SAM EC

PSB 4860 Version 2.1

Delta Sheet   07.97

**Delta Sheet for Target Specification 03.97**

**Figure 30**
**Speech Decoder - Block Diagram**

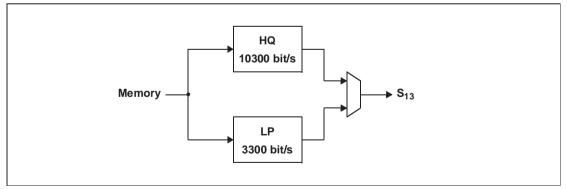
The block diagram of the decoder (figure 30, page 51) must be replaced by the following figure:

The register SDDATA and the bit SRC in register SDCTL do not exist any more.

**Figure 61**
**EPROM Interface - Connection Diagram**

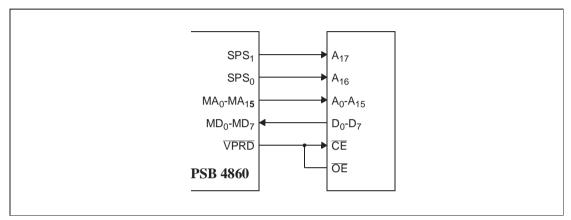
According to the Target Specification 03.97 the maximum size of the voice prompt EPROM is 512kBit (64kx8). The PSB 4860 Version 2.1 can now support up to 2MBit (256kx8). The necessary address lines $A_{16}$ and $A_{17}$ are provided by the pins $SPS_0$ and $SPS_1$. The EPROM interface (figure 61, page 93) should be replaced by the following figure:

In order to enable this feature an additional mode has been defined for the SPS pins. Please refer to section 7 for programming details.
